Service Bulletin

UPGRADED FRAMO STRIPPING / PURGING VALVE

**Upgraded stripping/purging valves
drg.no.264-363-2 & 293-514-2**

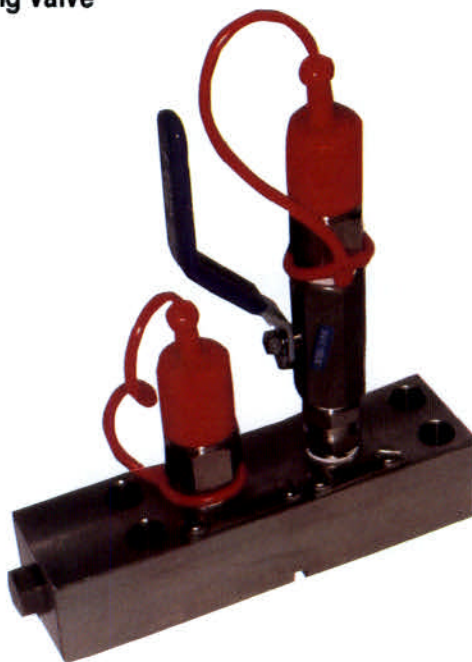
- Cargopump with the old design stripping/purging valve

-New design

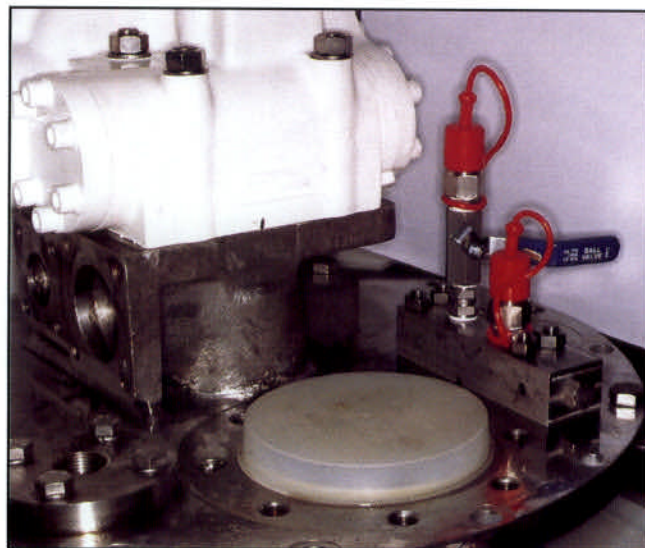
Old design stripping/purging valve fitted on topcover plate.

Upgraded stripping/purging valve fitted on topcover plate.

We are pleased to present the new upgraded FRAMO stripping and purging valves for the FRAMO cargo pump, our drg. no. 264-363-2 and 293-514-2. This modification is carried out according to the latest FRAMO design on new hydr. systems and class requirements. The drg. no. 264-363-2 replaces old design valve drg. no. 264-117-2 and drg. no. 293-514-2 replaces old design valve drg. no. 269-436-2.
